Subject: UniStar Nuclear Energy, NRC Docket No. 52-016
Response to Request for Additional Information for the
Calvert Cliffs Nuclear Power Plant, Unit 3,
RAI No. 54, Management and Technical Support Organization
RAI No. 55, Management and Technical Support Organization
RAI No. 59, Operating Organization
RAI No. 75, Fire Protection
RAI No. 98, Initial Plant Test Program

**Response to NRC Request for Additional Information,
RAI No. 54, Management and Technical Support Organization,
RAI No. 55, Management and Technical Support Organization,
RAI No. 59, Operating Organization,
RAI No. 75, Fire Protection, Question 09.05.01-5, and
RAI No. 98, Initial Plant Test Program,
Calvert Cliffs Nuclear Power Plant Unit 3**

**COLA Markup FSAR Section 13.1, ORGANIZATIONAL STRUCTURE OF APPLICANT
Calvert Cliffs Nuclear Power Plant Unit 3**

Figure 13.1-2—{Project Delivery Organization}

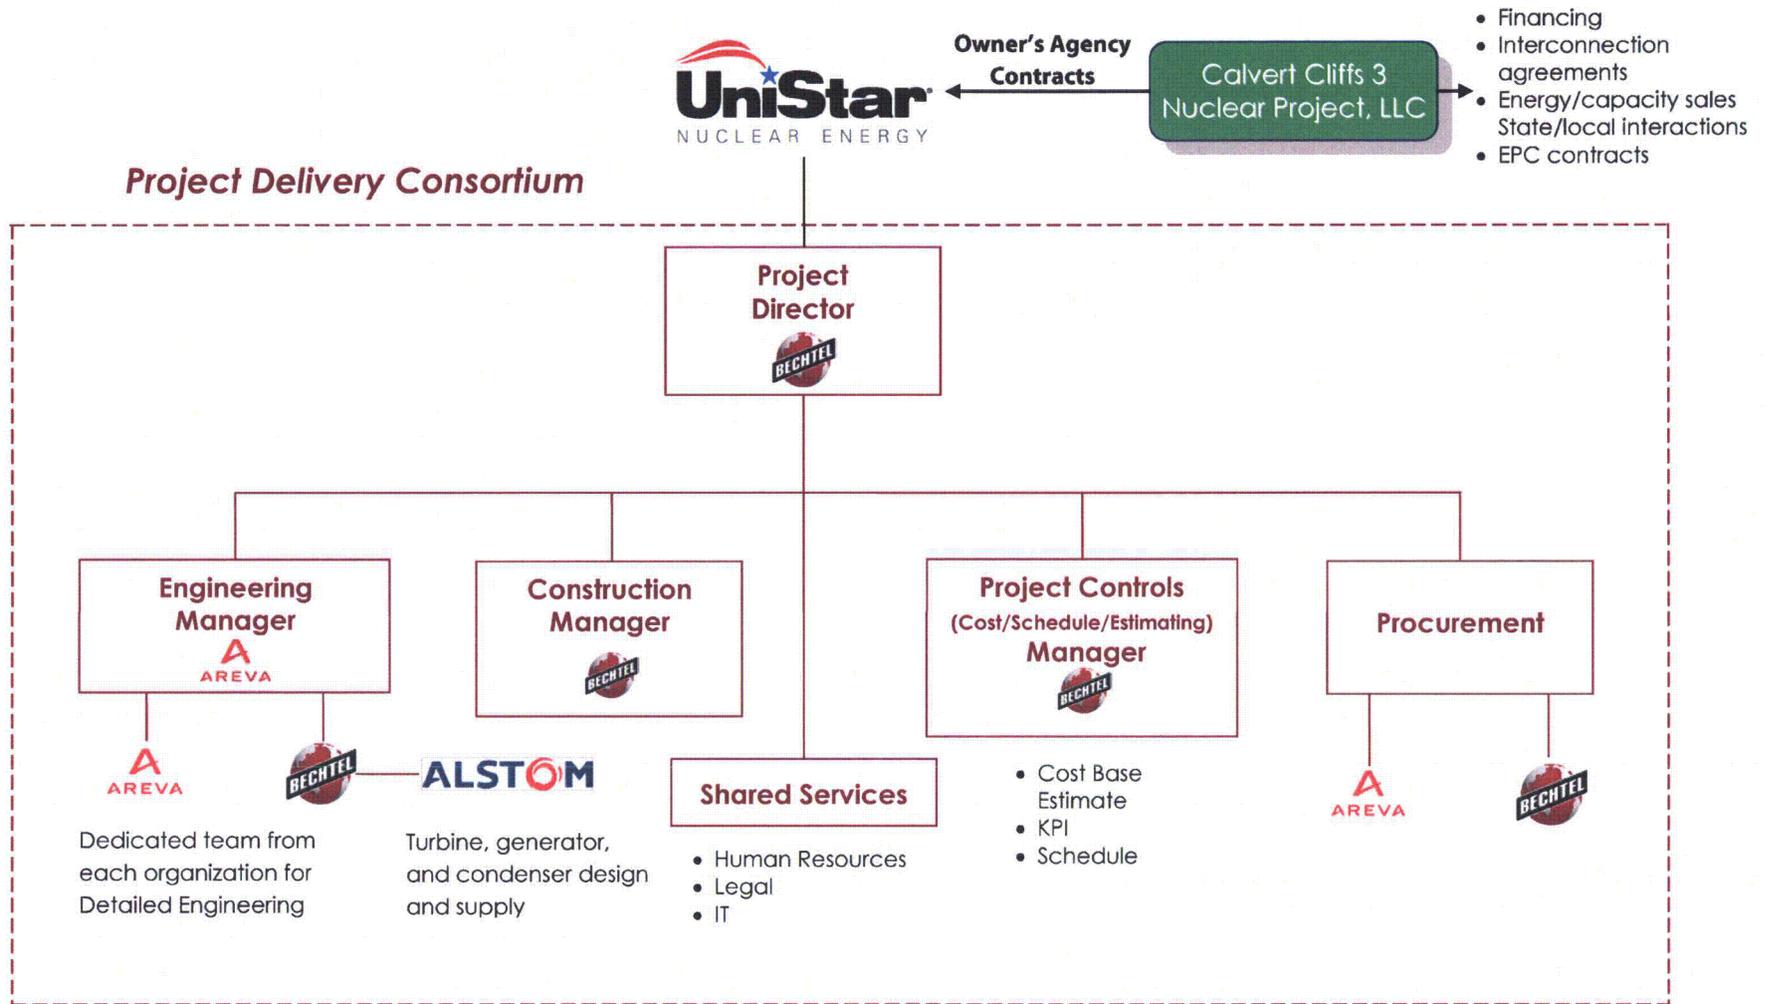
Standard Review Plan Section 13.1.1, "Management and Technical Support Organization," section I.1.B.viii requests the applicant describe how its management interfaces with the NSSS and AE organizations for design, construction and preoperation.

The Calvert Cliffs 3 Nuclear Project, LLC has entered into contracts with AREVA and Bechtel for design and construction, which are collaborating in a Consortium combining the NSSS supplier and architect engineering roles for the CCNPP Unit 3 project. The Project Delivery Consortium is discussed in FSAR Section 13.1.1.1.1.6. FSAR Figure 13.1-2 includes a diagram of the interfaces within the Consortium.

FSAR Sections 13.1.1.1.1.6 and Figure 13.1-2 and other FSAR Section 13.1 subsections will be updated in a future COLA revision as indicated in Enclosure 2.

Figure 13.1-3—{UNE Corporate Organization}

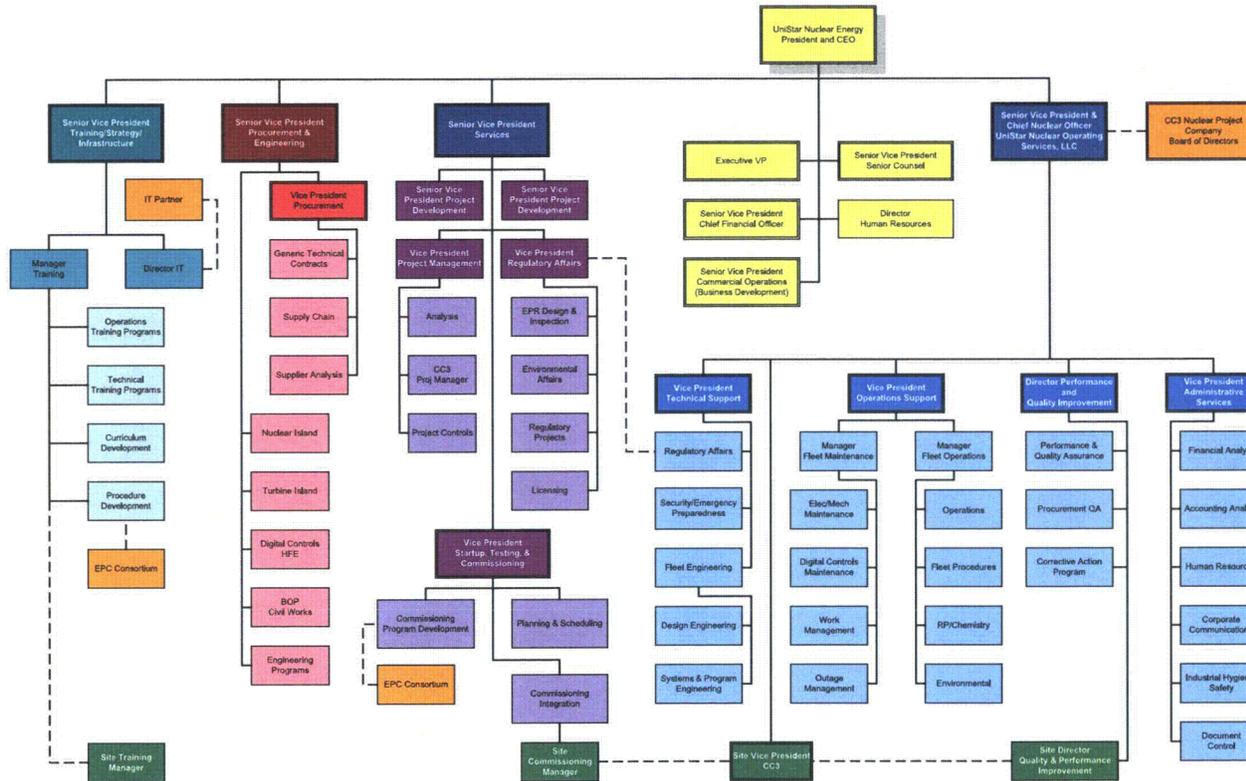
Standard Review Plan Section 13.1.1, "Management and Technical Support Organization," section I.2.A. states that the applicant's FSAR should provide the following information: Organizational charts of the applicant's corporate level management and technical support organizations.

Standard Review Plan Section 13.1.1, "Management and Technical Support Organization," section I.2.B and RG 1.206, section C.I.13.1.1.2, "Organizational Arrangement", request the applicant to provide the relationship of the nuclear-oriented part of the organization to the rest of the corporate organization.

Figure 13.1-3 includes a diagram of the UNE Corporate Organization and Figure 13.1-4 includes a diagram of the UNO Site Organization.

Figure 13.1-3 and Figure 13.1-4 and other FSAR Section 13.1 subsections will be updated in a future COLA revision as indicated in Enclosure 2.

FSAR Section 13.1.1.2 discusses the organization arrangement. Figure 13.1-3 includes a diagram of the UNE Corporate Organization and Figure 13.1-4 includes a diagram of the UNO Site Organization. Figure 13.1-3 delineates the relationships between the affiliated companies, including the relationship between the nuclear oriented parts to the non-nuclear parts of UniStar Nuclear Energy. FSAR Section 13.1.1.2.2 includes a discussion of the relationship of the nuclear organization to the non-nuclear organization.

Figure 13.1-3, Figure 13.1-4, FSAR Sections 13.1.1.2 and 13.1.1.2.2, and other FSAR Section 13.1 subsections will be updated in a future COLA revision as indicated in Enclosure 2.

Figure 13.1-4—{UniStar Nuclear Operating Services, LLC Site Organization}

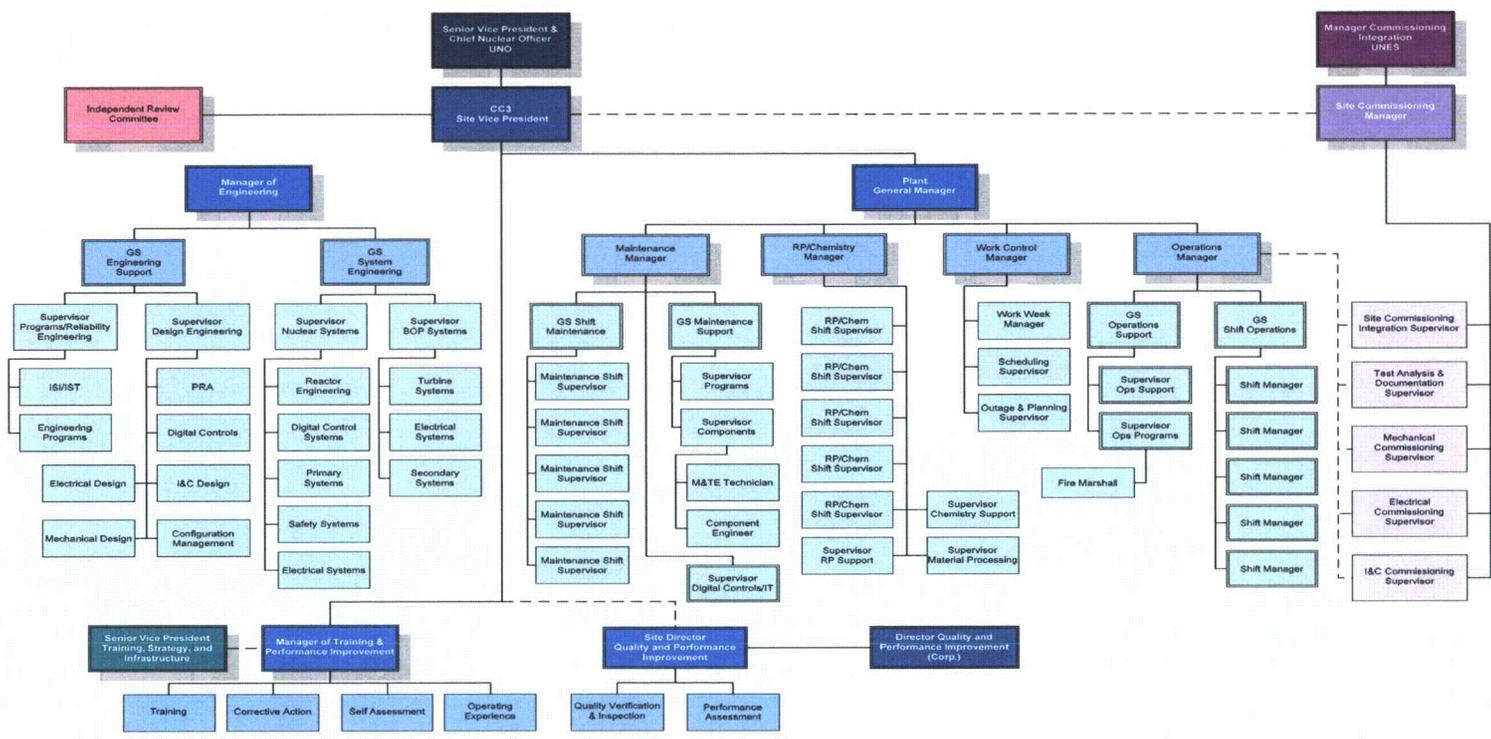
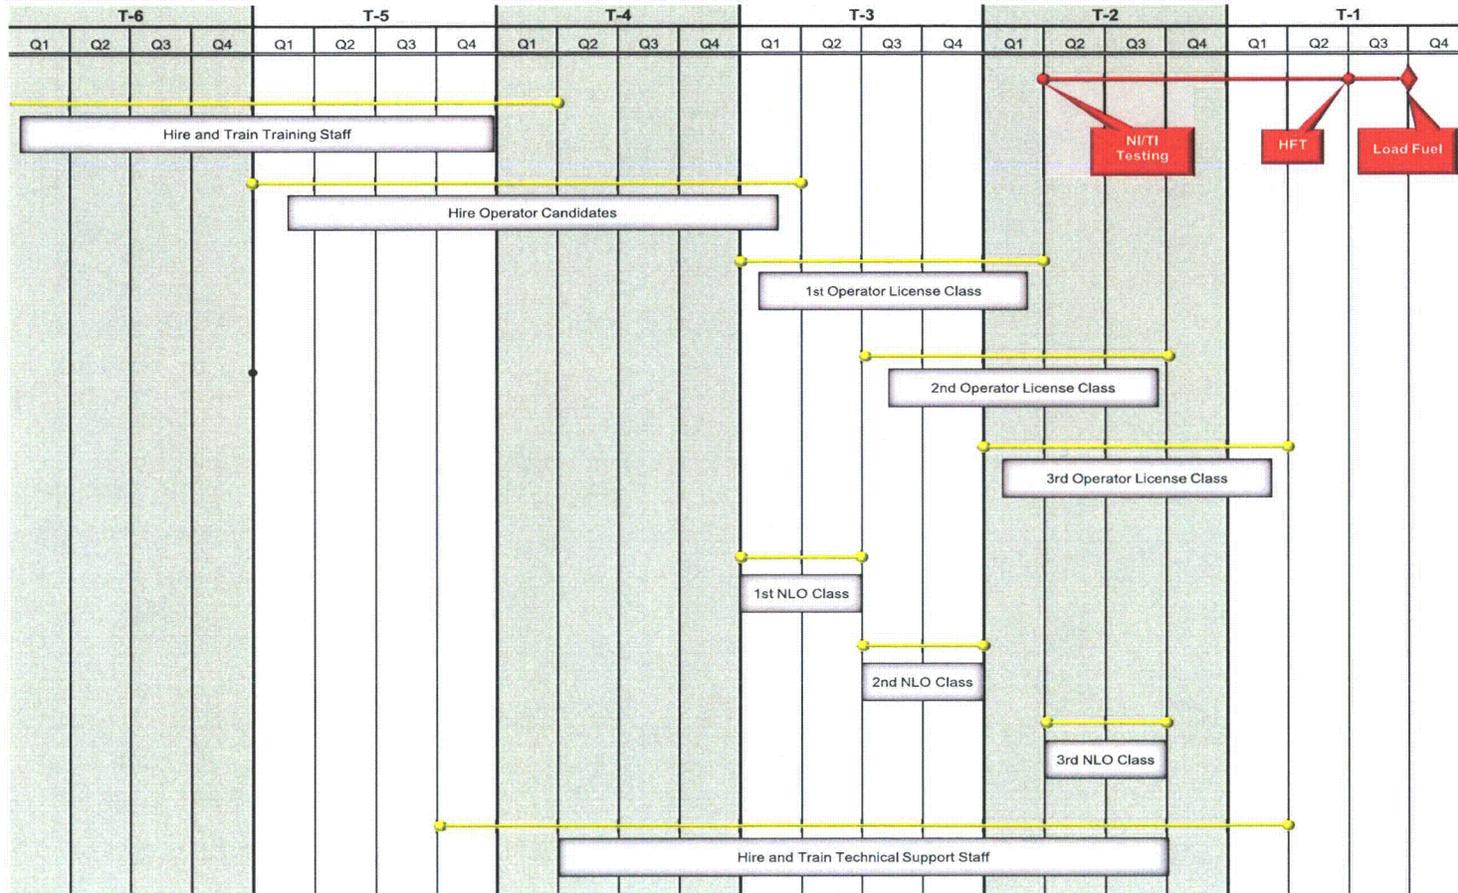
Please provide this information for fire protection supervisors and quality assurance supervisor, describe where this information can be found in the application, or justify an alternative.

Ensure that FSAR Section 9.5.1.6.2, Figure 9.5-1, and Section 13.1.2 which reference Section 17.5 which incorporates Topical Report NO. UN-TR-06-001 are consistent with one another. Section 9.5.1.6.2 states that the overall responsibility for the FPP rests with the Chief Nuclear Officer which is not described in UN –TR-06-001 or shown in Figure 9.5-1 which shows the overall responsibility for the FPP belonging to the Executive Management Position Responsible for Facility Operations. Include all of the key positions described in RG 1.189 in Section 9.5.1.6.2 and Figure 9.5-1 and ensure UN-TR-06-001 is consistent with Section 9.5.1.6.2 and Figure 9.5-1.

Fire Protection is discussed in FSAR Section 13.1.1.1.2.10.7. This Section indicates that the Site Vice President, Operations Fire Marshall, an engineer, and the fire brigade have roles with respect to fire protection. FSAR Section 13.1.2.2.1.1 states that the Plant General Manager has a role with respect to implementation of the fire protection program through the Fire Marshall. The engineering function related to support of the Fire Protection Program is provided by personnel reporting to the General Supervisor – Engineering Support as indicated in FSAR Section 13.1.2.2.1.2.2. The positions identified in these Sections are included in Figure 13.1-4.

FSAR Figure 13.1-4, UniStar Nuclear Site Organization, has been added to the FSAR which shows the UniStar Nuclear Operating Services, LLC Site Organization as well as the UNE Startup, Test, and Commissioning Group (under Site Commissioning Manager) organization of the startup organization. The chain of command is indicated and an additional statement in position description is not necessary.

UniStar Nuclear Energy has performed an update of FSAR Section 13.1. The proposed markup of Section 13.1 is included in Enclosure 2. The UniStar Nuclear Operating Services, LLC site organizational structure is represented in Figure 13.1-4.

FSAR Figure 9.5-1 has been deleted since the FPP organization is represented in FSAR Figure 13.1-4 (Enclosure 2) and the key site specific management positions are represented in this figure. FSAR Table 9.5-1, Fire Protection Program Compliance with Regulatory Guide 1.189, position C.1.1 and position C.1.6, column titled "CCNPP Unit 3 Supplement" has been modified to reflect the appropriate discussion based on the changes described above. The UniStar Nuclear Quality Assurance Program Description will be modified to reflect these changes in the next scheduled update.

The UniStar Nuclear Operating Services, LLC site organizational structure is represented in Figure 13.1-4. The site specific management positions for the FPP identified above are included in Figure 13.1-4.
